**Subject: Brown's Business Development Preliminary Engineering Review**

It was requested that an engineering review of Brown's business development be completed by Crestline Engineers, Inc. in accordance with City of New Meadows ordinances and applicable governing business development regulations. It is our understanding that Bill and Donna Brown are proposing a multiple operation business at 400 N. Norris Street on lots ten (10) through eighteen (18) of town block number eighty four (84). The proposed business is anticipated to include retail sales, an auto repair shop, used automobile and farm machinery sales, car wash, and commercial storage facilities. This engineering review was conducted in accordance with the City of New Meadows Ordinances and the 2005 City of New Meadows Comprehensive Plan. Additionally, it was reviewed with regard to American Disability Act (ADA) and Idaho State Fire Code compliance.

Front View

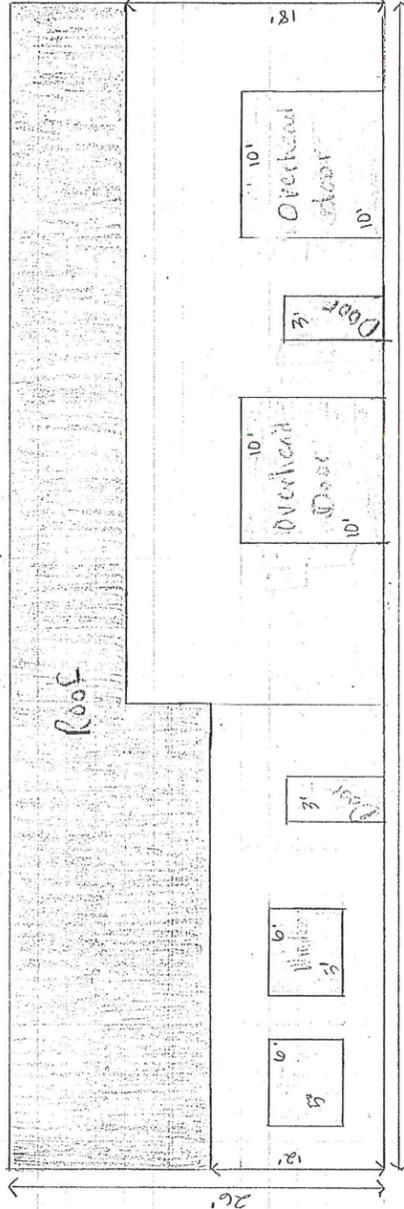
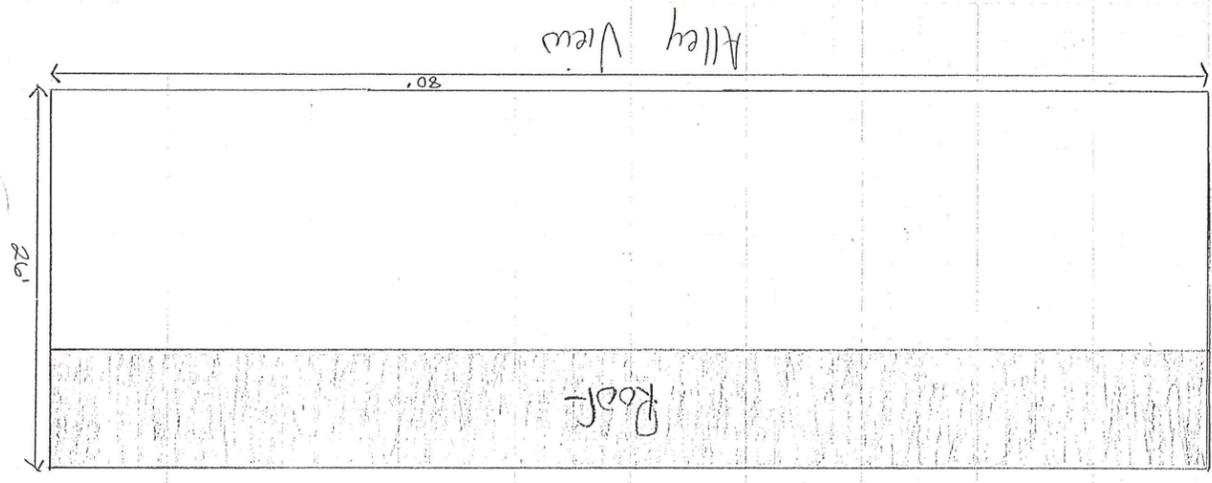
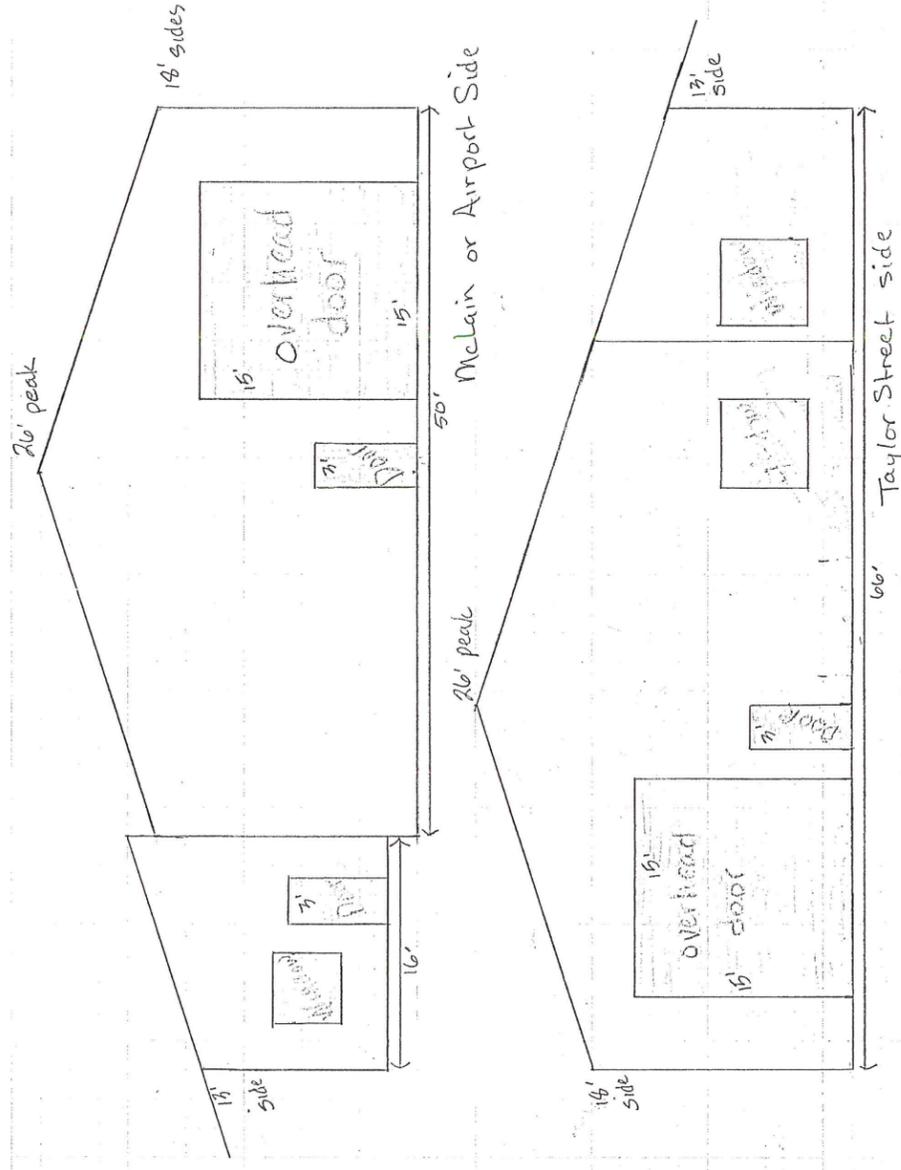
Windows have not been purchased. They may change size.

“Red-lined” Site Plan showing conflict of setbacks and parking lot layout

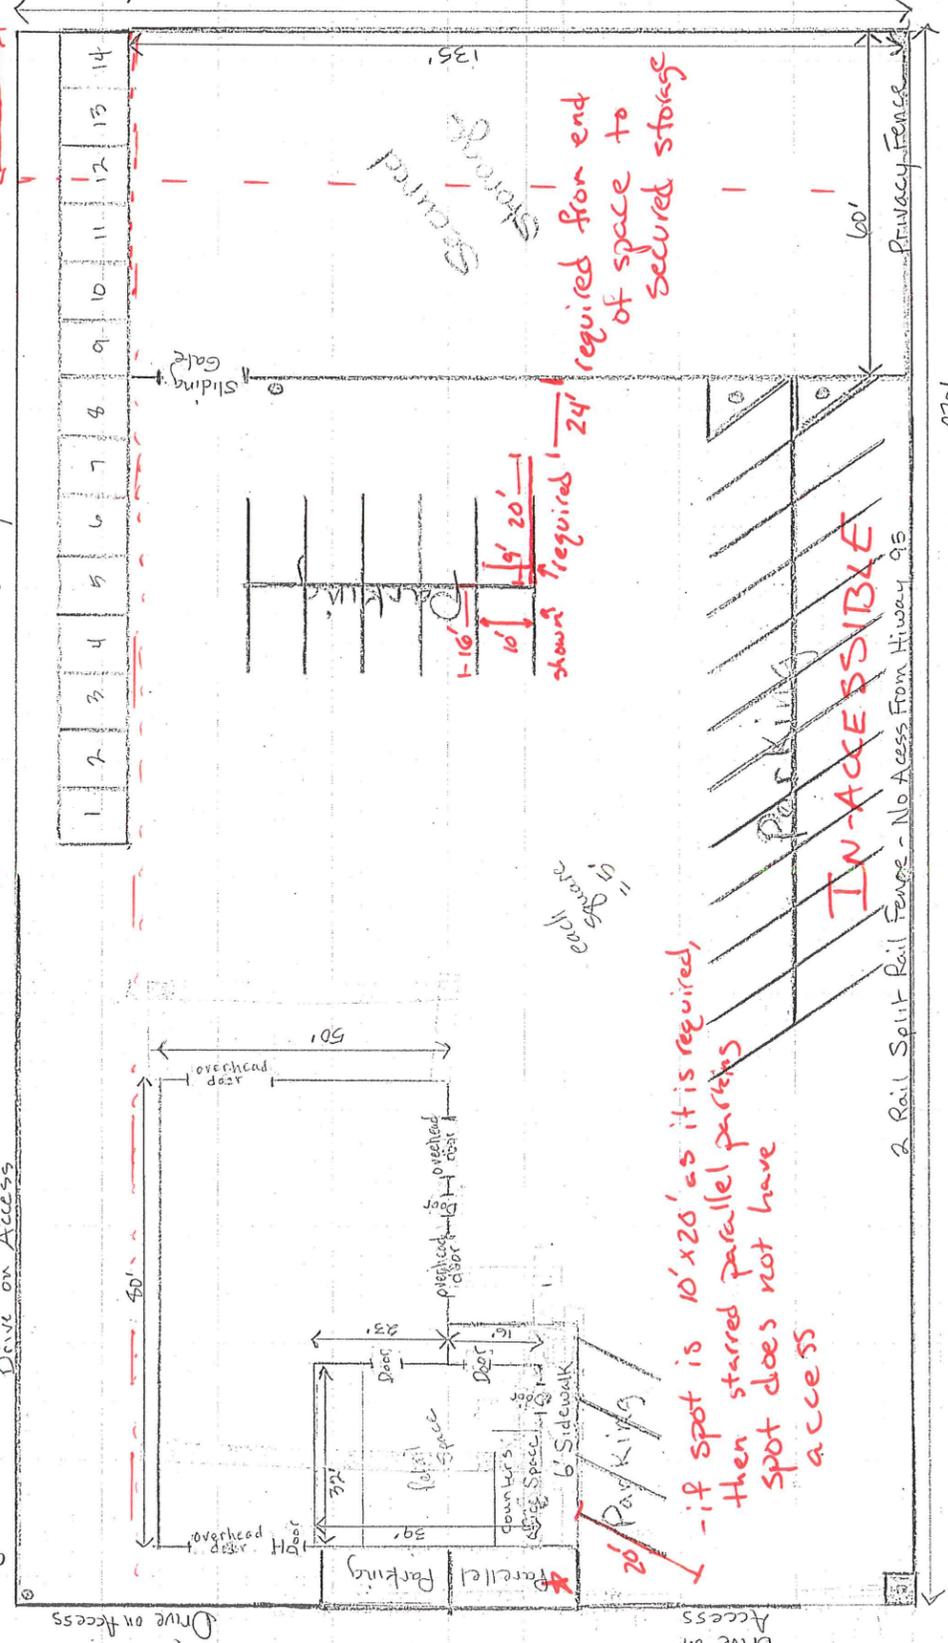
site plan shows approximately seven (7) feet from the property line to the edge of the proposed storage buildings, which is in conflict with the fifteen (15) foot setback requirement.

- C) Zone "C" requires a twenty five (25) foot rear yard setback. The proposed storage units are shown on the site plan to be at the property line, are in conflict with the twenty five (25) foot rear yard setback.
- D) Total lot coverage of all buildings shall not exceed sixty percent (60%). As shown on the site plan, the proposed repair shop is 3,264 S.F, the proposed attached office is 1,248 S.F, and the proposed storage facilities cover approximately 4,200 S.F. The two hundred seventy (270) foot by one hundred fifty five (155) foot property is 41,850 S.F. The buildings cover approximately 21% of the lot, which is in accordance with this ordinance.
- E) Required parking shall have alley access and meet parking requirements as set in Section 16 of the New Meadows City Zoning Ordinance. Parking is addressed in this review after the completion of the Section 8 review.

The parking spaces shown on the site plan located perpendicular to the secured storage space are located too close to the secured storage. Per the required parking aisle widths in Section 16-5 there must be twenty four (24) feet between the parking spaces nearest to the secured storage facility based the angle of the spaces as shown on the proposed site plan. It appears that the spaces are located approximately twelve (12) feet from the secured storage area.

25' - back yard setback  
15' side yard setback

Storage required from end of space to secured storage

24' required

-if spot is 10' x 20' as it is required, then stalled parallel parking spot does not have access

**IN-ACCESSIBLE**
